Bid Bulletin #01

PROJECT: Shelton Public Schools
Additions & Alterations
Shelton, NE

DATE: March 21, 2014

**ADDITIONS & ALTERATIONS TO
SHELTON PUBLIC SCHOOLS
PROJECT NO. R-21113**

SHEET C400

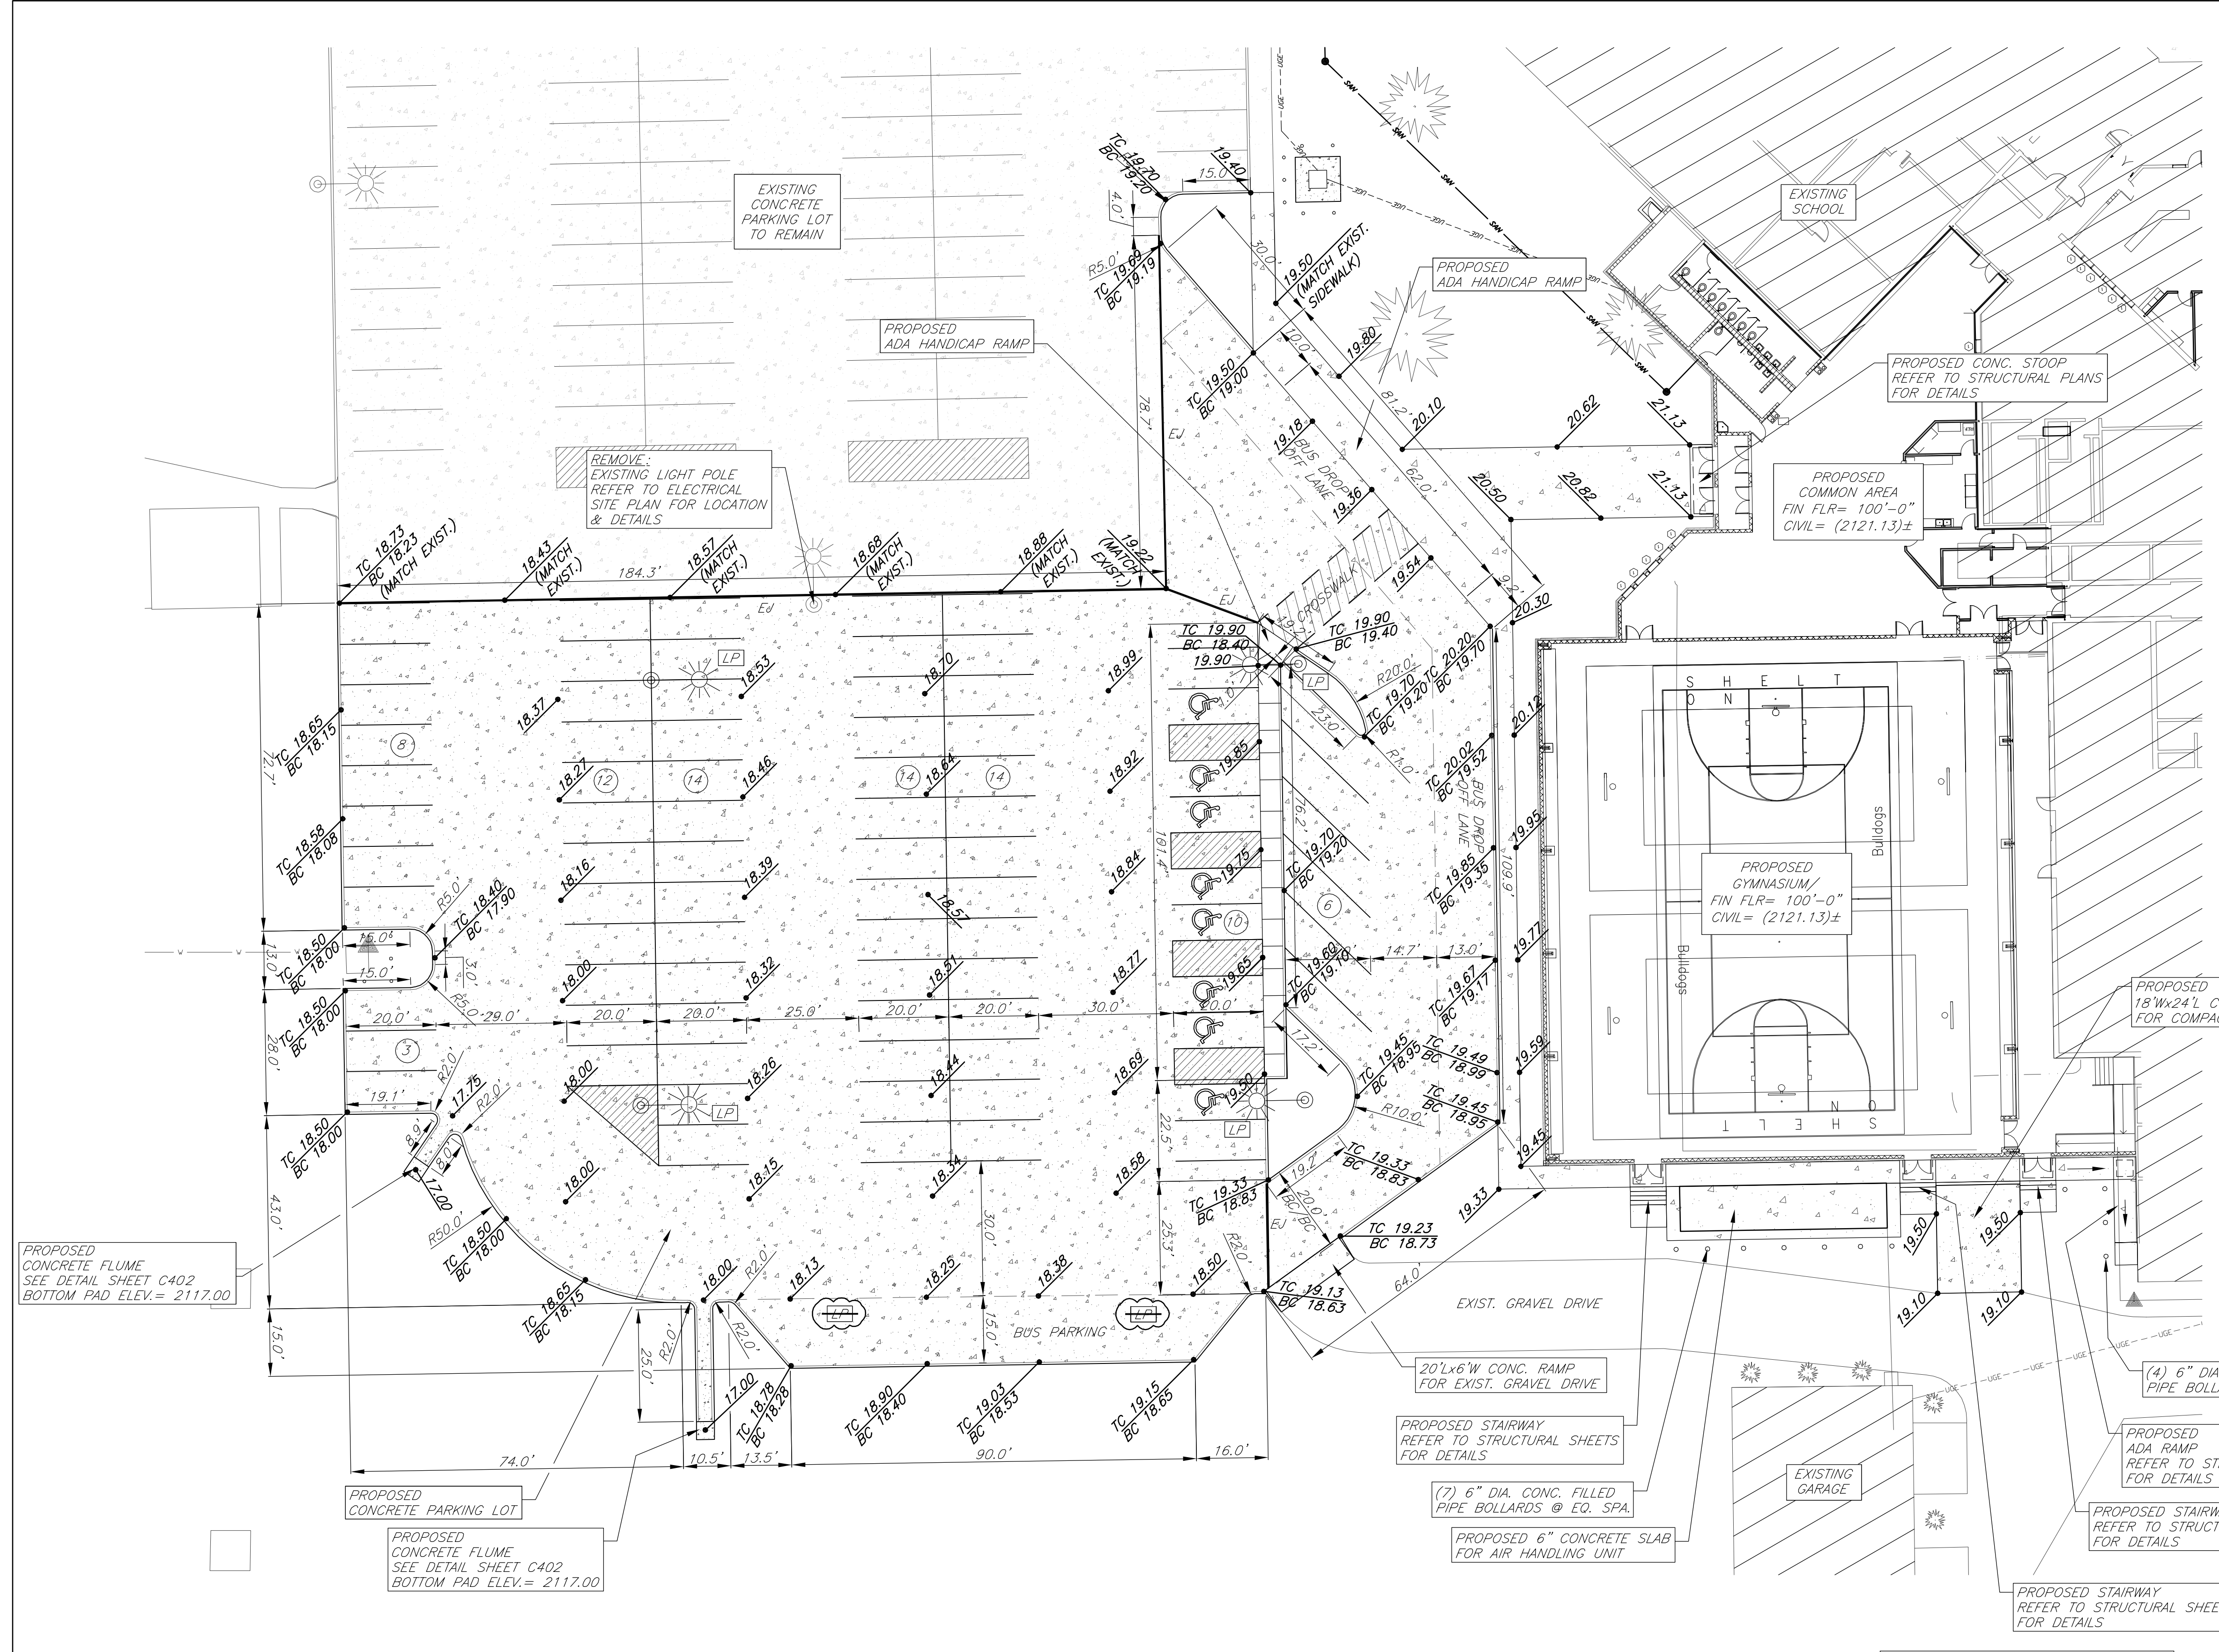
- a. Revisions include the removal of the two (2) parking lot lights located at the south end of the west parking lot were not part of the electrical site plan and therefore shall be removed.

SHEET C401

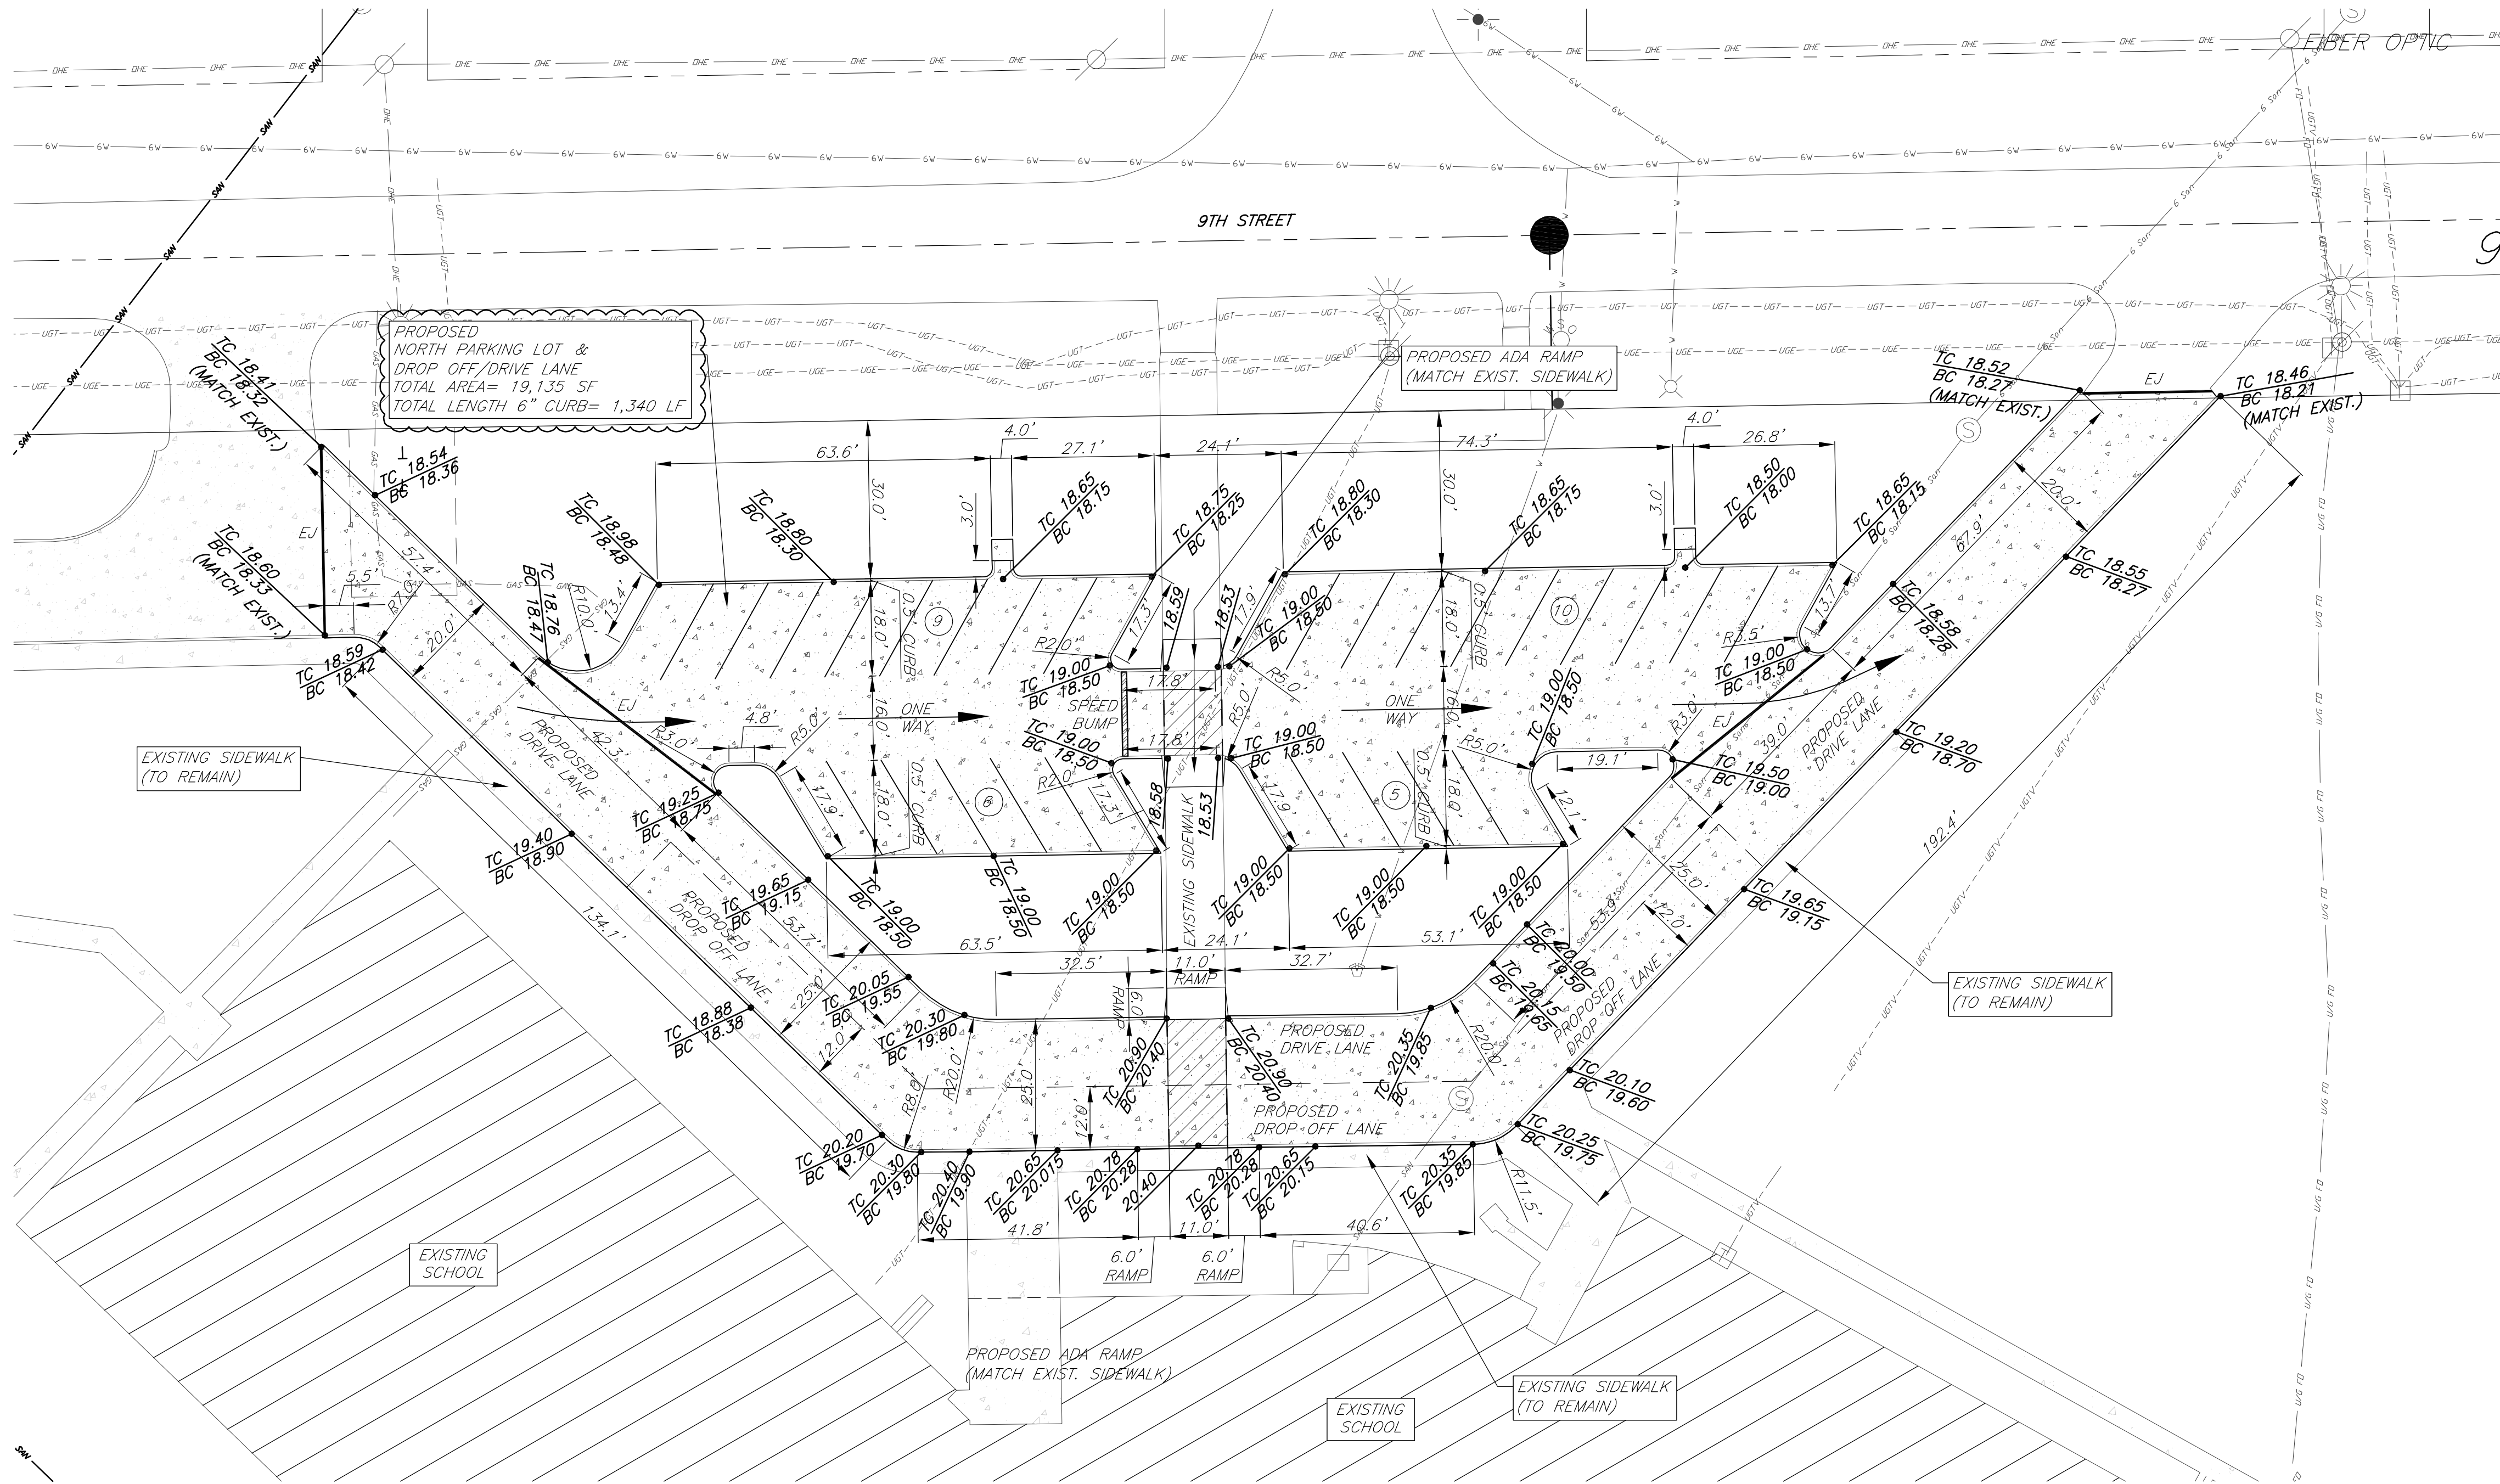
- a. The parking lot and driveway at the north end of the existing school has been modified. These revisions include repaving the driveway to include a through lane and an unloading lane. Also, the north parking lot has been moved approximately ten feet (10') to the south from the original design so that the existing tree line at the north side of the school can remain. This movement of the parking lot has reduced the number of stalls in this parking lot.
